REMARKS/ARGUMENTS

Claims 1-4 are currently amended. Corrected drawing sheets, replacing drawing pages 1 and 2 which contain Figs. 1 and 2, are attached.

Fig. 2

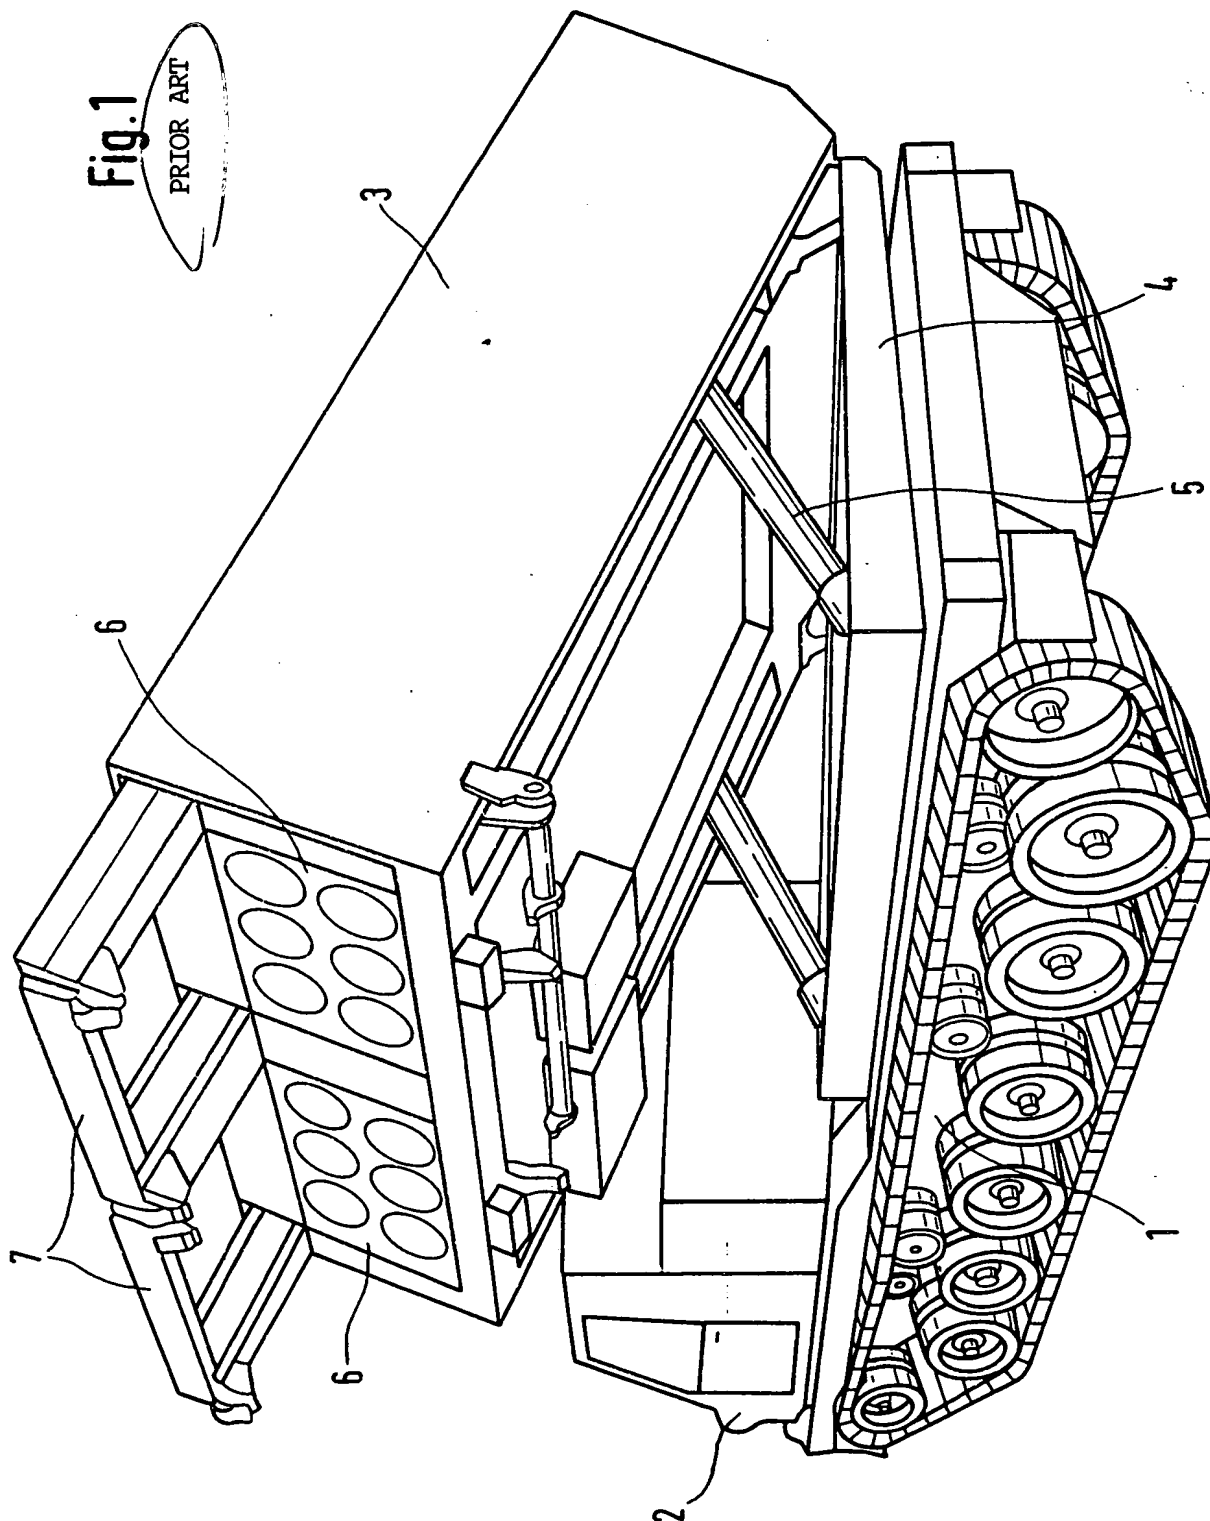
The Examiner has objected to the drawings, indicating Figs. 1 and 2 should be indicated as "Prior Art". The Applicant appends replacement drawing pages in response hereto.

The attached sheets of drawings include changes to Figs. 1 and 2. These sheets replace the original sheets containing those same figures and include the legend "PRIOR ART". Fig. 3 is unchanged but is included for drawing uniformity

PRIOR ART
